FISH PASSAGE CENTER

MEMORANDUM

RE: Review Performance Standard Testing/ John Day 2010

RE: Review of Acoustic Telemetry Evaluation of Juvenile Salmonid Passage at John Day Dam, 2009 Draft Final Report

Figure 3.29. Spill treatments as prescribed (red line) and actual conditions (black line) in spring (repeated from Figure 3.22 for ease of reference)

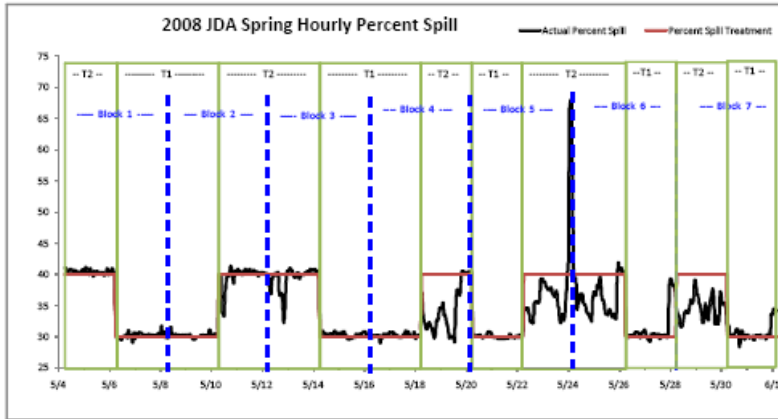
Based on our review of the PNNL 2008 acoustic telemetry study it is difficult to determine how the steelhead survival estimates were grouped to arrive at the numbers reported both in the PNNL 2008 report to the COE and in the Weiland et al. presentation to AFEP 2010. In both the 2008 report and the 2010 presentation by PNNL the paired steelhead survivals in 2008 were 99.1% for the 30% spill treatment and 97.2% for the 40% spill treatments. However, upon using the average survival for the virtual release blocks from the appendices of the 2008 report and the date blocks identified in Figure 3.29 from 2008 PNNL report, we estimated the paired release survival at were 99.0% for the 40% nominal spill treatment group when we took a simple average of the survival blocks, while the 30% group average survival was 97.7%. We also considered sample size weighted average estimates and found the same pattern; with the 40% spill test having a 99.2% average survival compared to 97.8% average for the 30% tests. Finally, we also pooled detection tallies for all blocks within each treatment and estimated a paired release survivals of 98.6% for the 40% treatment blocks compared to 97.6% for the 30% blocks. Our results are the opposite of what PNNL is reporting and lends confusion to the consideration and application of these results to operations decisions. In all of the methods we used to combine the data; the 40% blocks appeared to have higher survival than the 30% blocks, which is opposite of what was reported in the PNNL reports.
